ADDENDUM #3

PROJECT: Rapid Valley Elementary School Addition and Remodel
DATE: March 16, 2026
BID DATE: March 19, 2026 at 2:00pm MST

PROJECT ADDENDUM NO. 03

ADDENDUM NO. 3 - MECHANICAL

DATE: 3/2/25
SHEET NO: A201

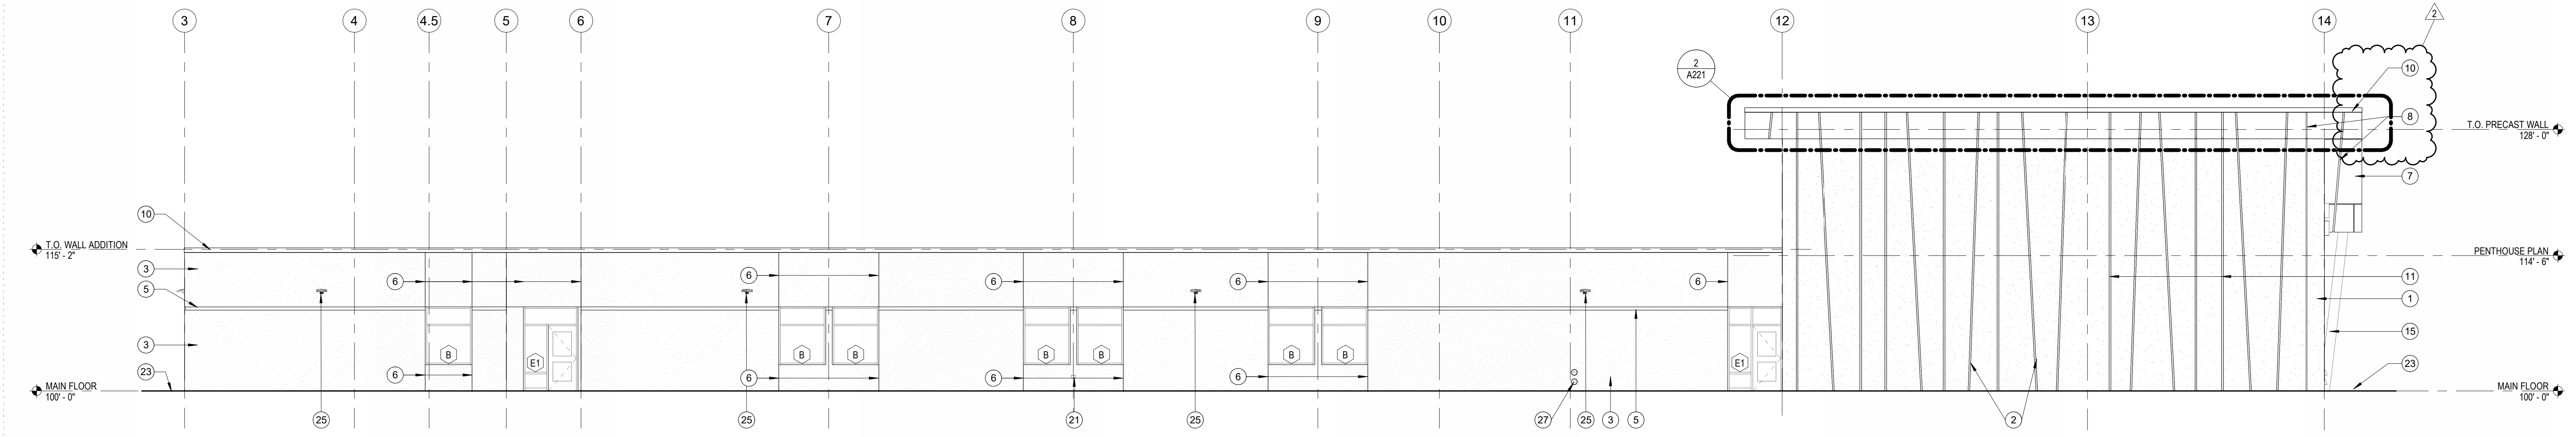
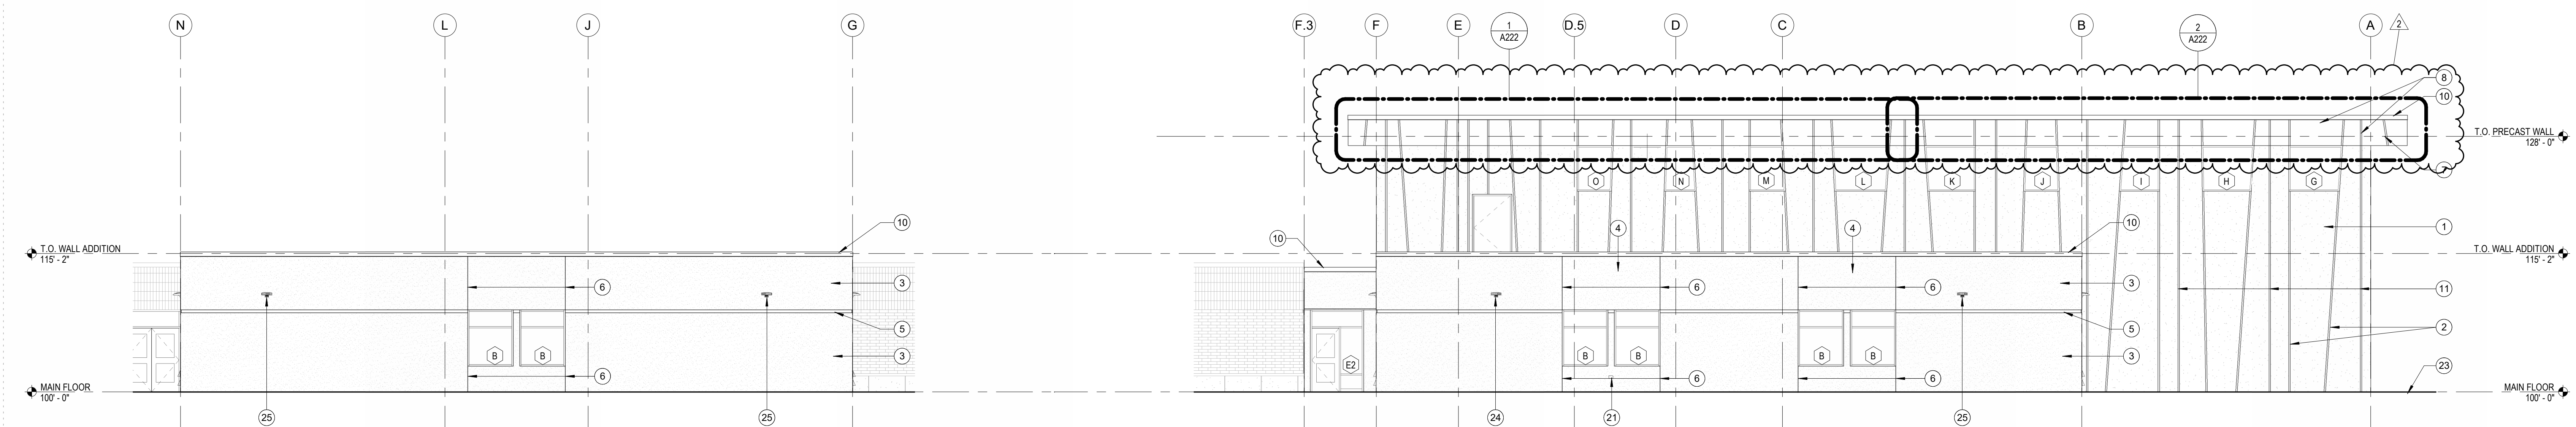
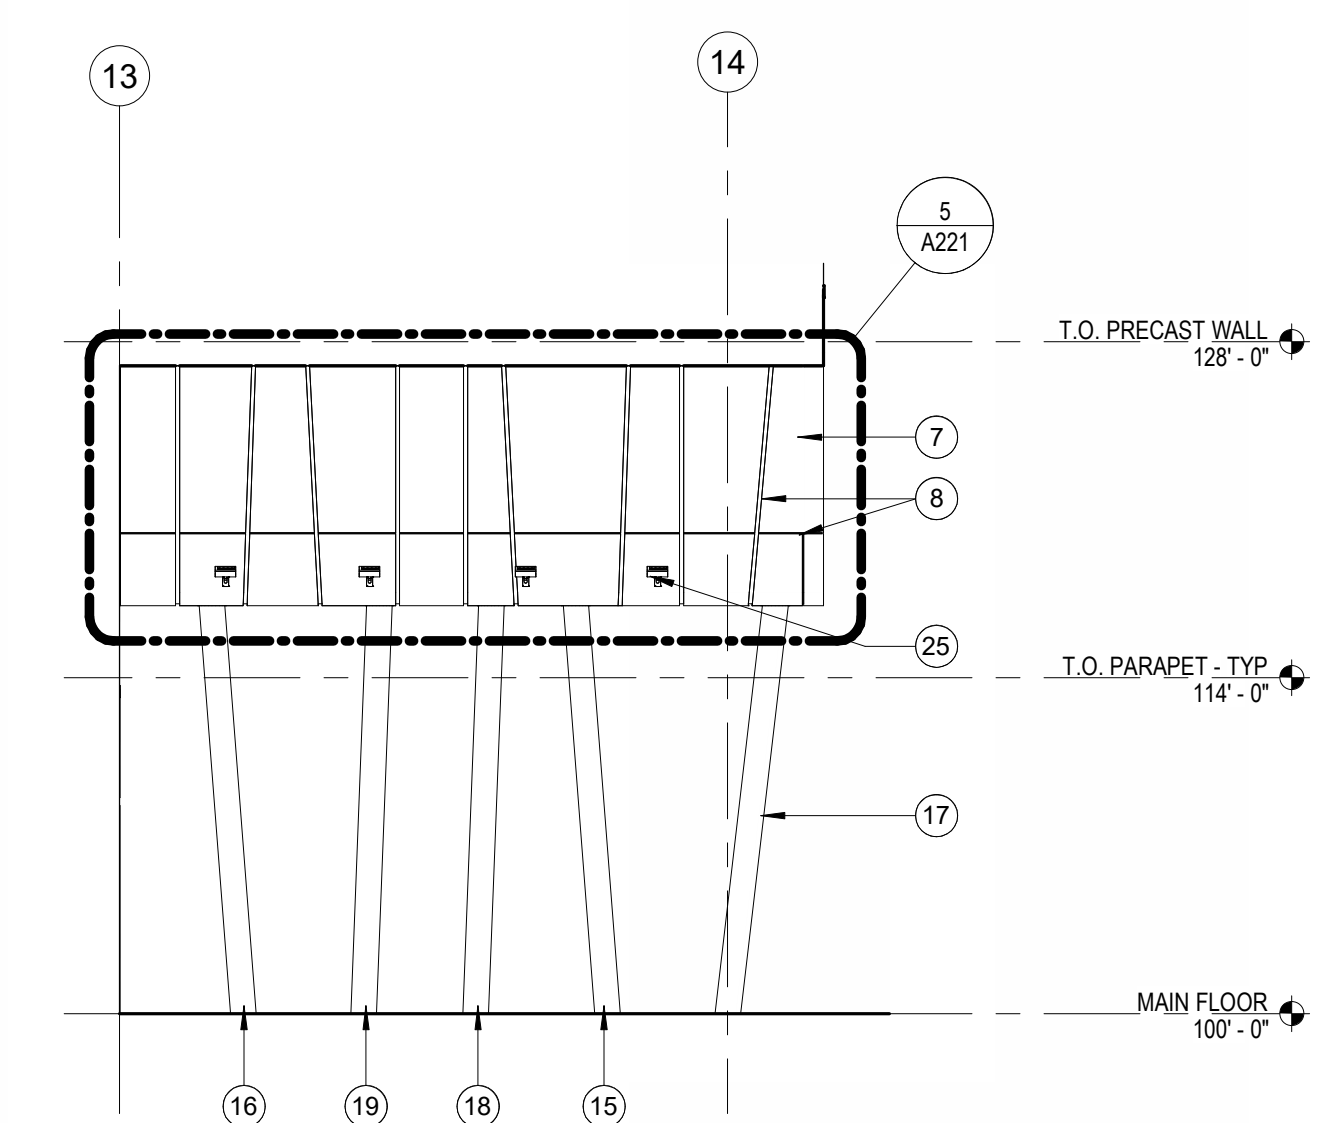
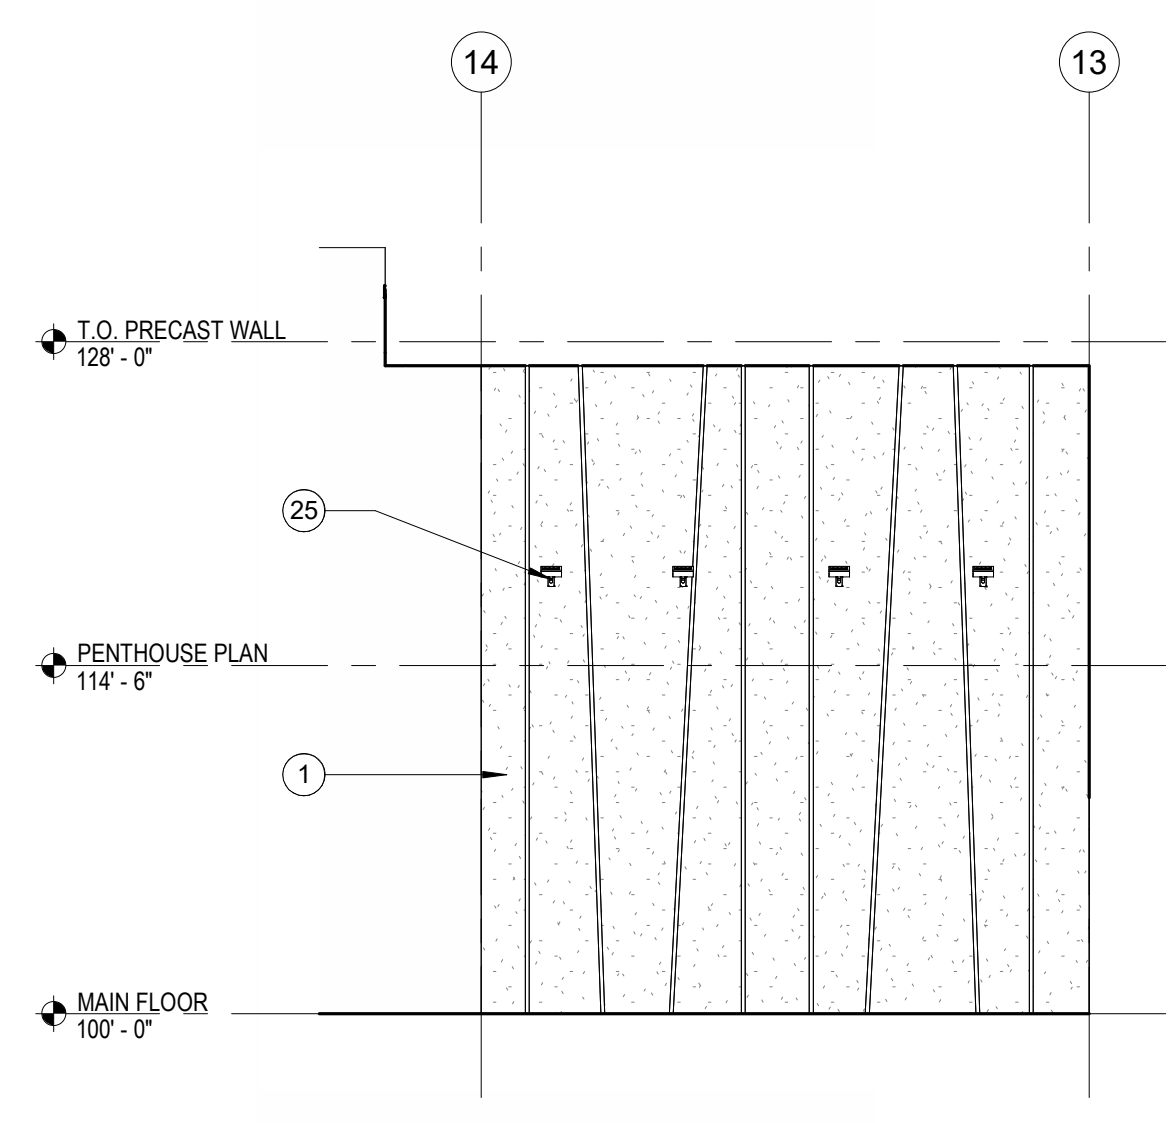
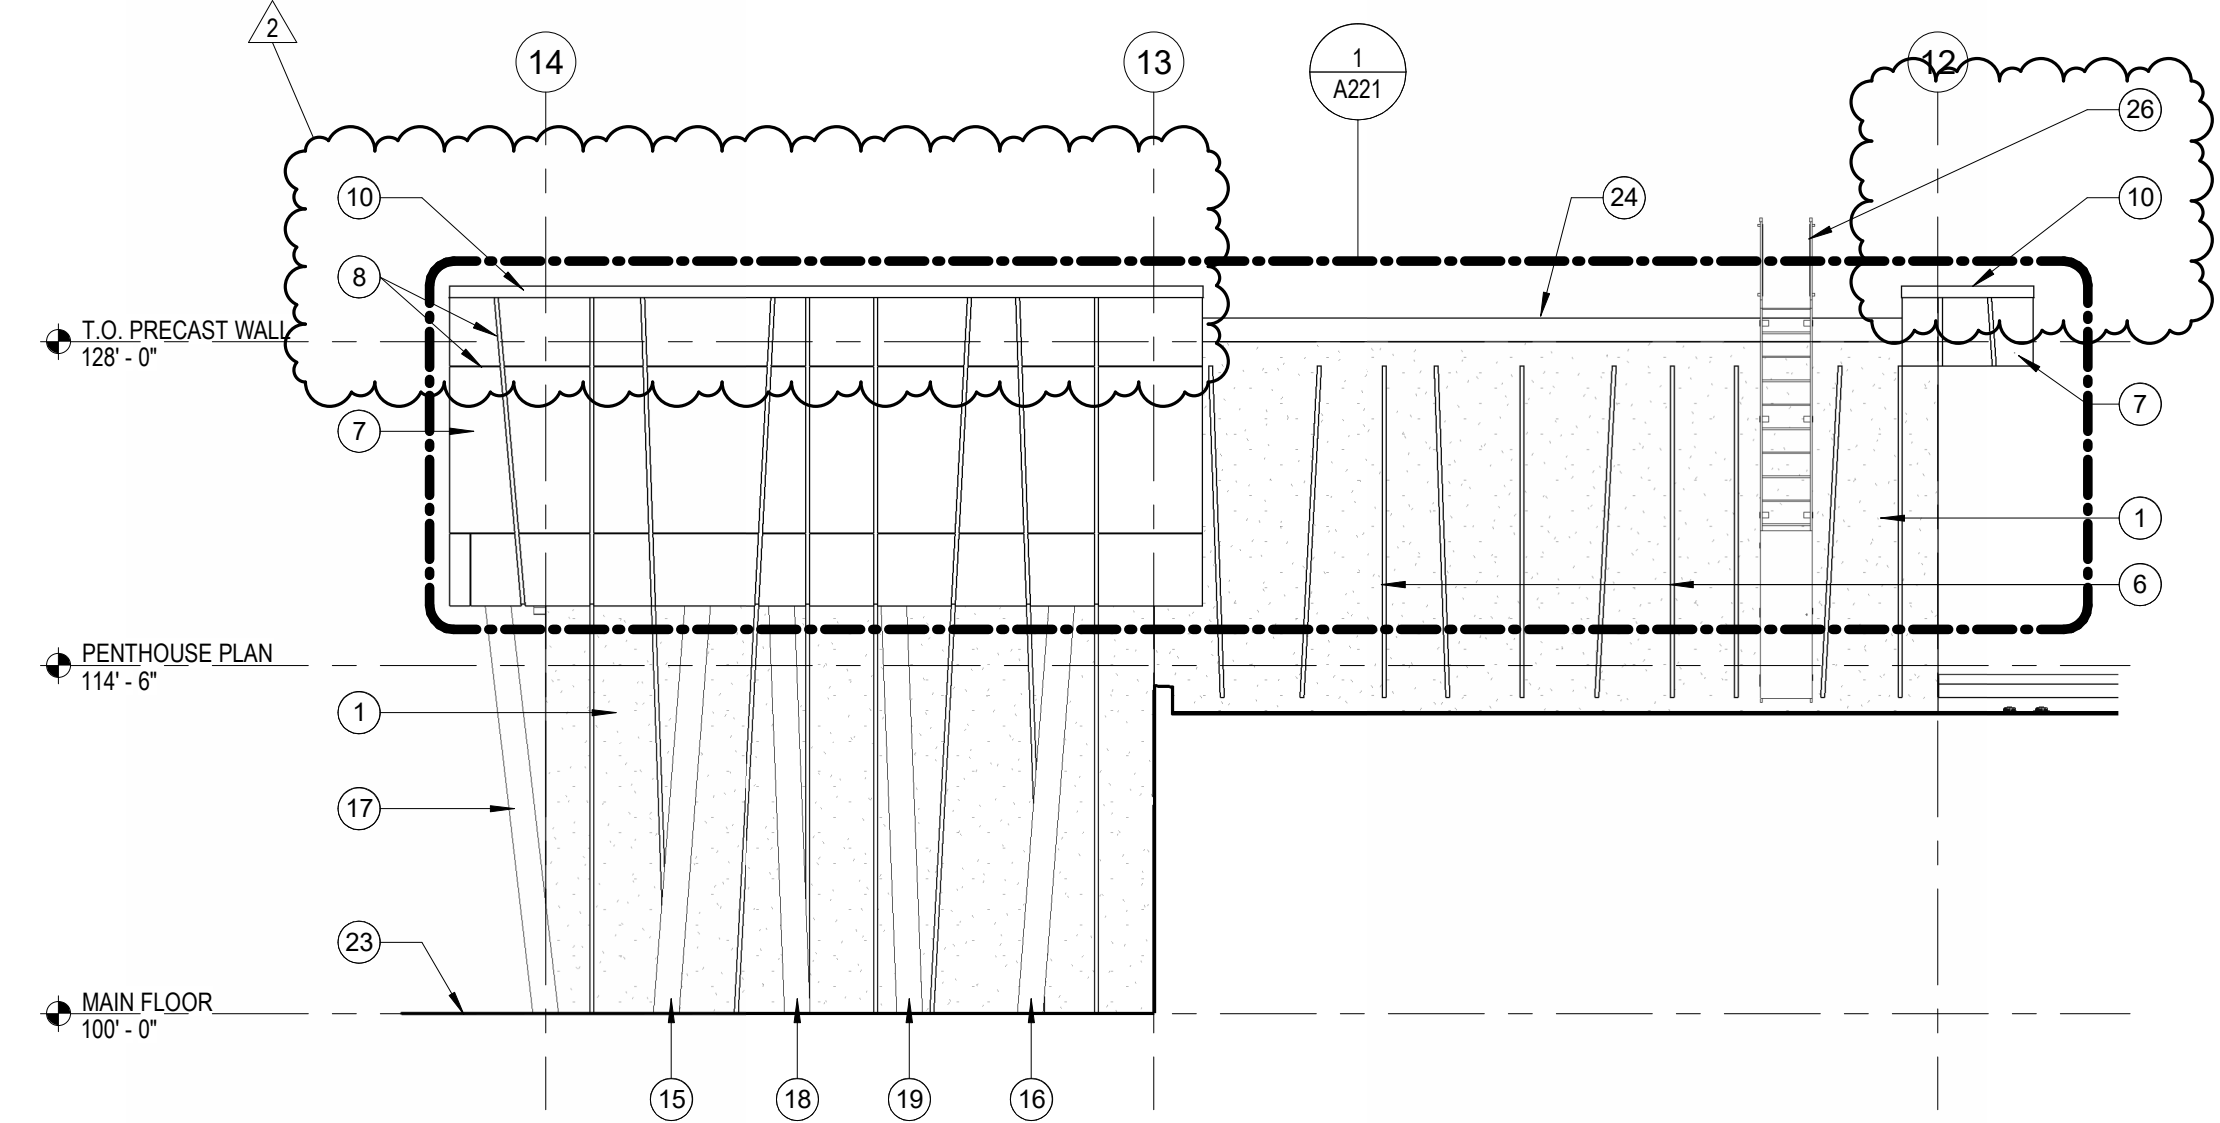
ADD 3-10 A201 – EXTERIOR ELEVATIONS
 1. Revise elevations for parapet copying.
